### Addendum 1

Project File Architect's Project #: 20210121.50
Project Name: Hulbert EMS

- 1. Sheet CS Cover Sheet
  - 1.1 Removed exterior sheathing
- 2. Sheet A101 FLOOR PLAN AND ELEVATIONS
  - 2.1 Adjusted door schedule
  - 2.2 Added note for skirt board
- 3. Sheet S101 FOUNDATION PLAN AND FOUNDATION DETAILS
  - 3.1 Revised detail 10/S101

# ADDENDUM 01 – HULBERT MARSHAL/EMS BUILDING EXPANSION

**COVER SHEET**

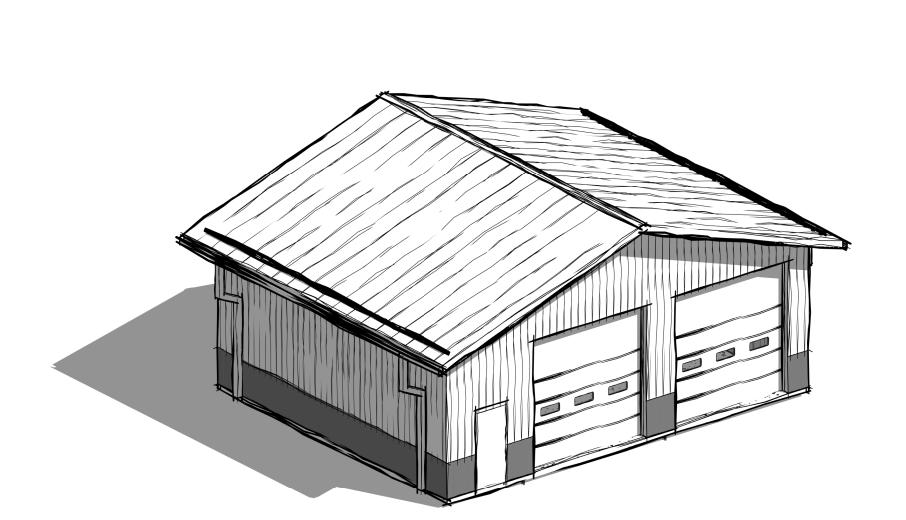
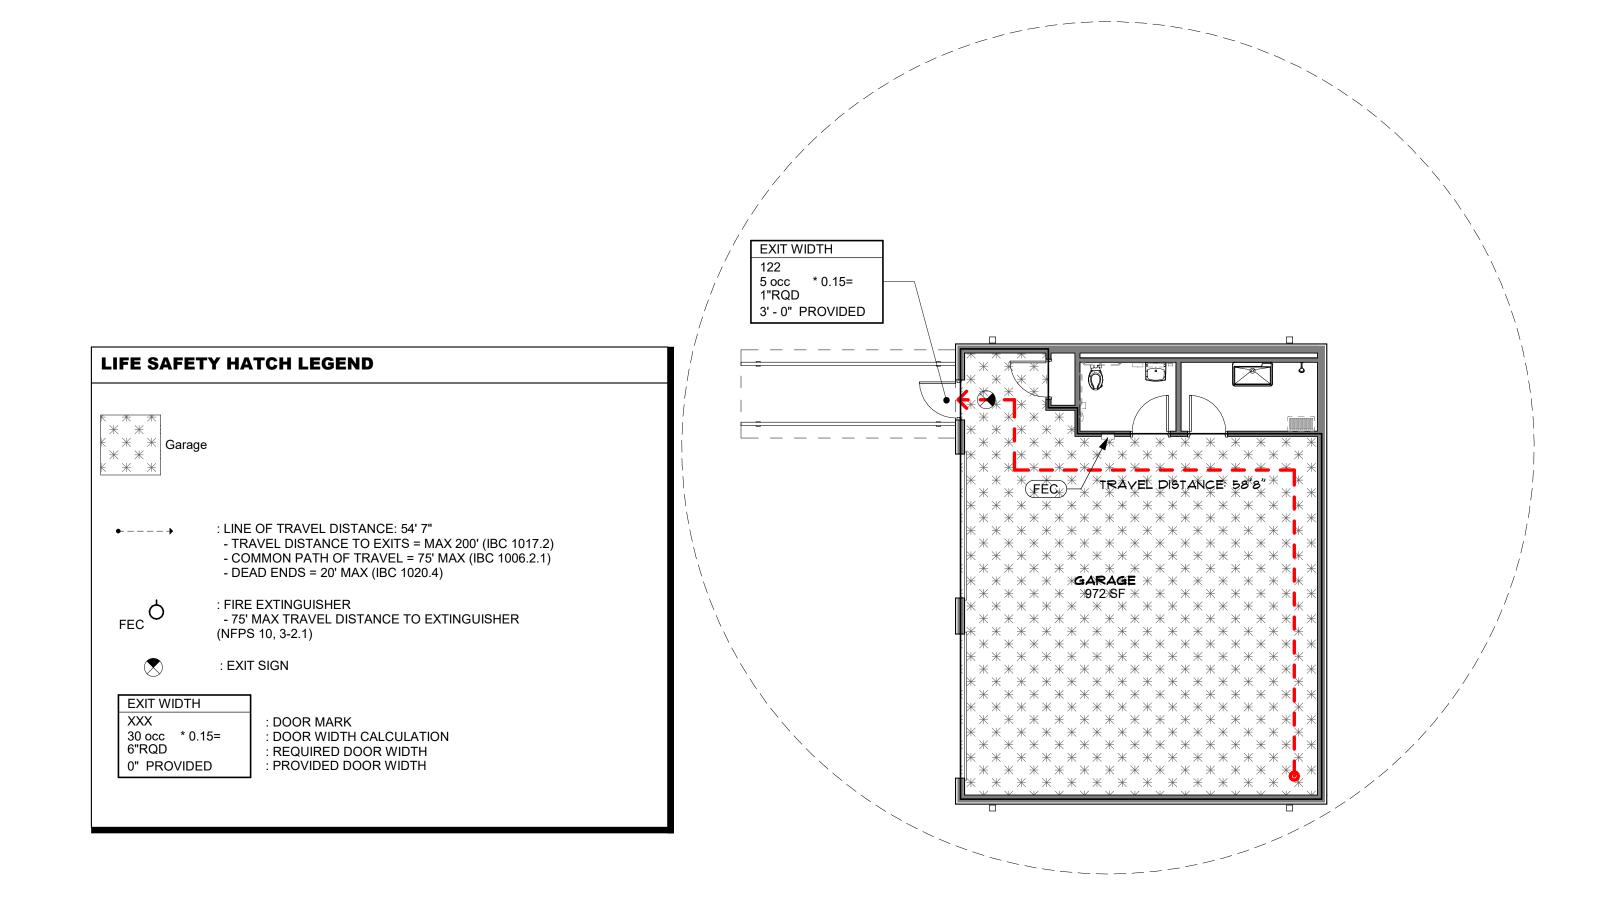
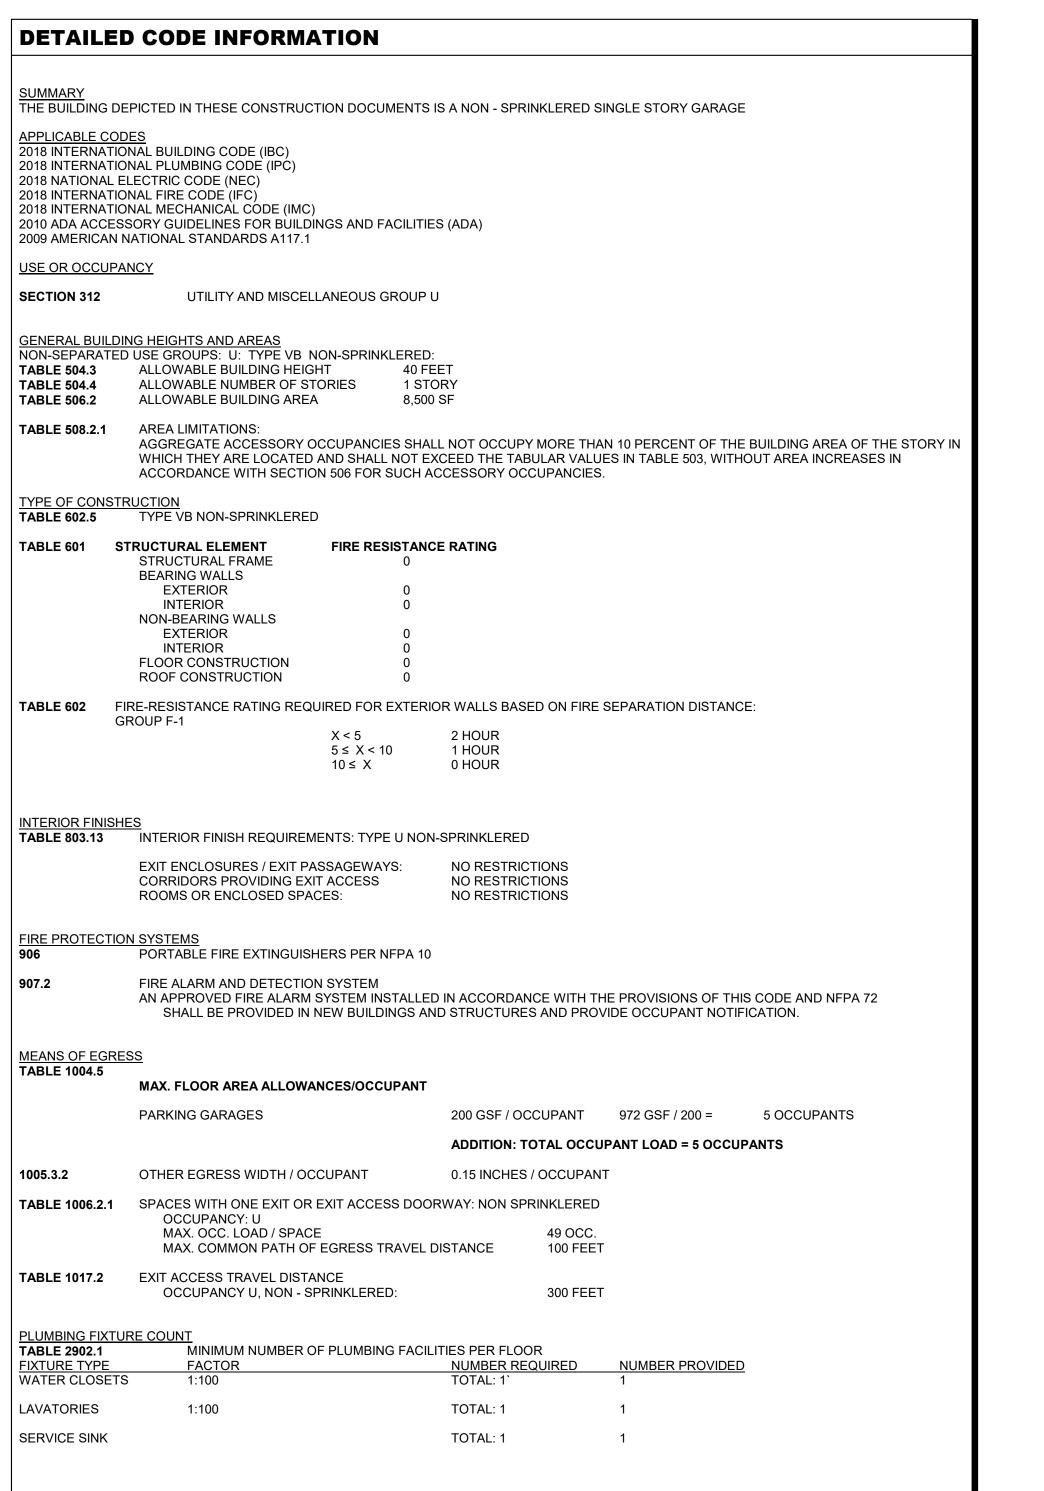
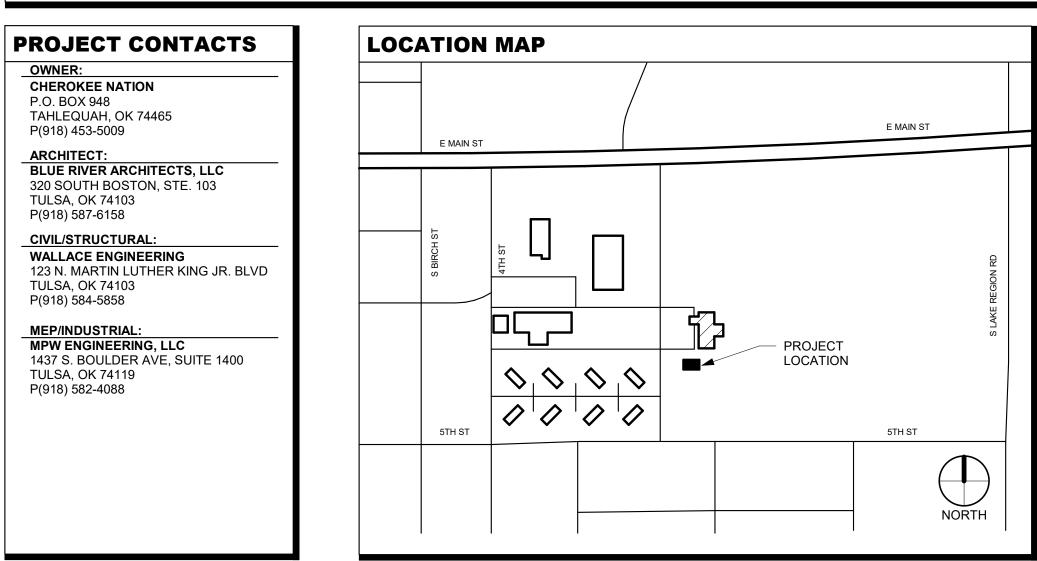
12. Cover Sheet Notes call for 7/16" exterior wall sheathing. Typical post frame building only have wall girts without wall sheathing. Is that acceptable?

ANSWER: Yes, this is acceptable.

FLOOR PLAN AND **ELEVATIONS**

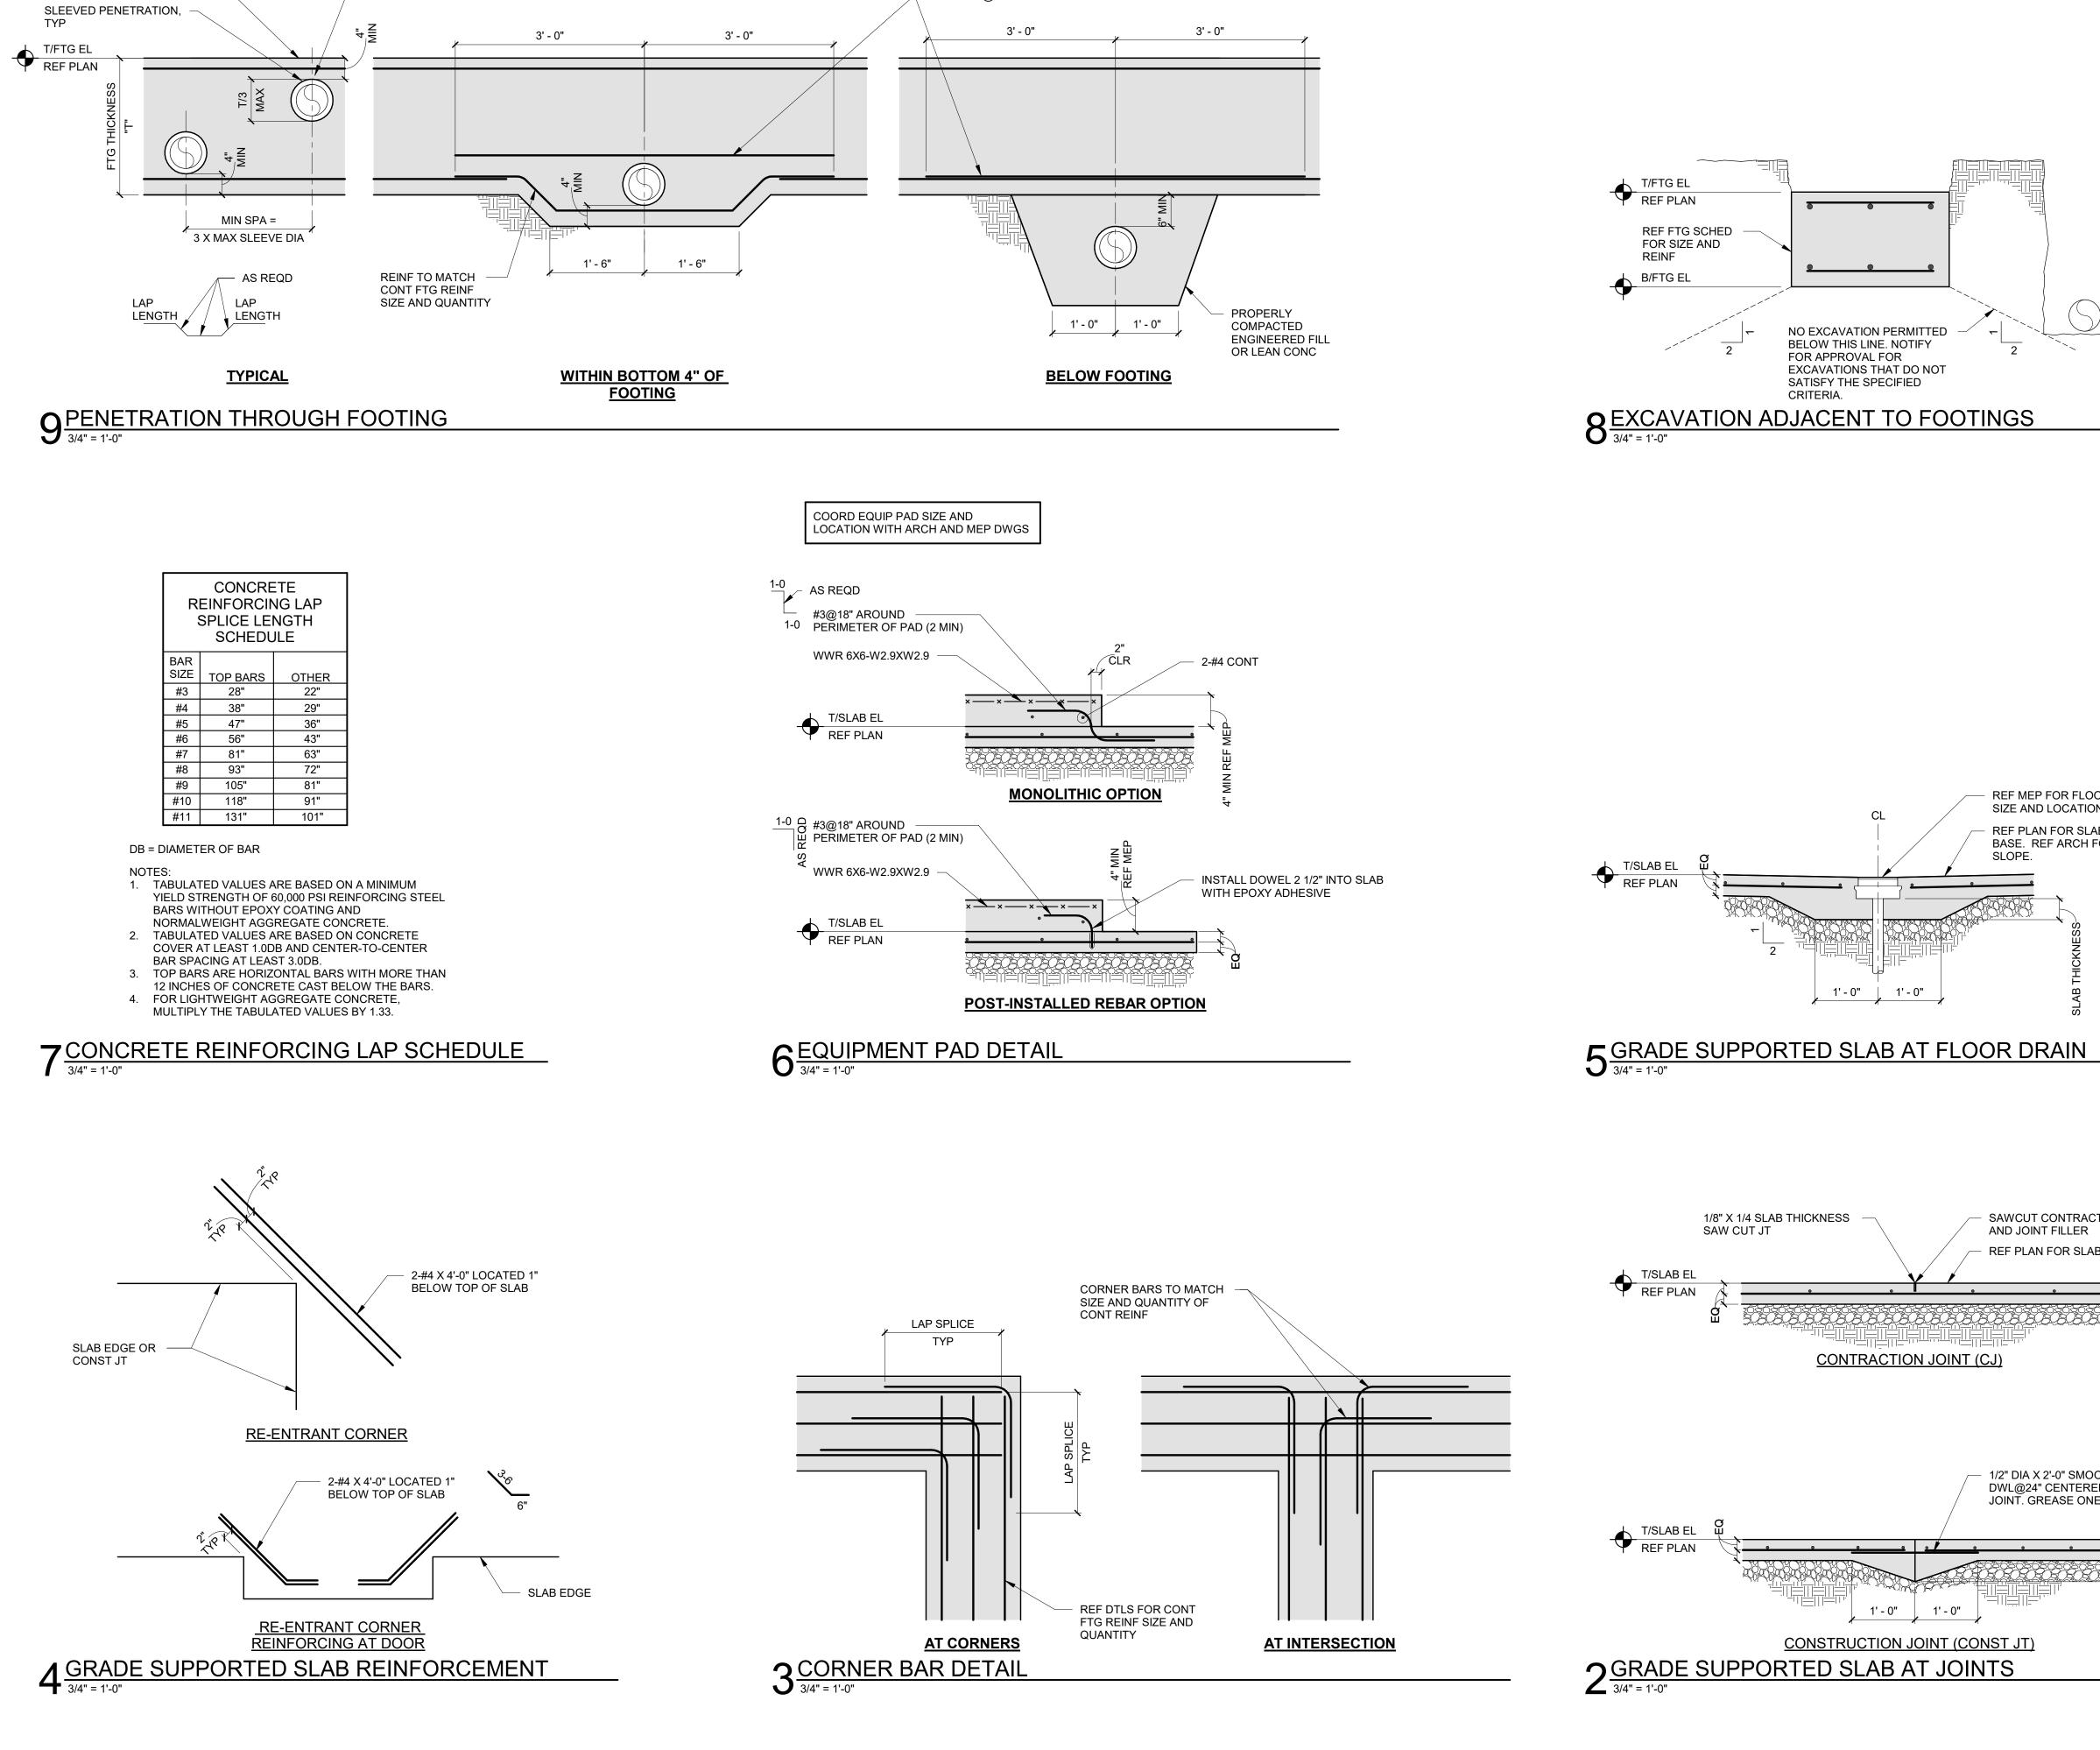
1. A101-WHERE IS DOOR #105?

8. DETAIL F ON A101 – ARE THE GIRTS TO BE INSTALLED BETWEEN THE POLES OR FASTENED TO THE OUTSIDE FACE OF THE POLES? POLE BARNS TYPICALLY INSTALL GIRTS ON THE OUTSIDE FACE. PLEASE CONFIRM INTENT.

9. DETAIL F ON A101 – PURLIN INSTALLATION IS NOT CLEARLY CALLED OUT. TYPICALLY, ON POLE BARNS, PURLINS ARE MOUNTED DIRECTLY TO THE TRUSSES. PLEASE CONFIRM INTENDED INSTALLATION METHOD.

ANSWER: Door #105 has been removed from the project.

ANSWER: Girts are to be installed between the poles.

ANSWER: Purlins to be installed per pole barn manufacturer's recommendation
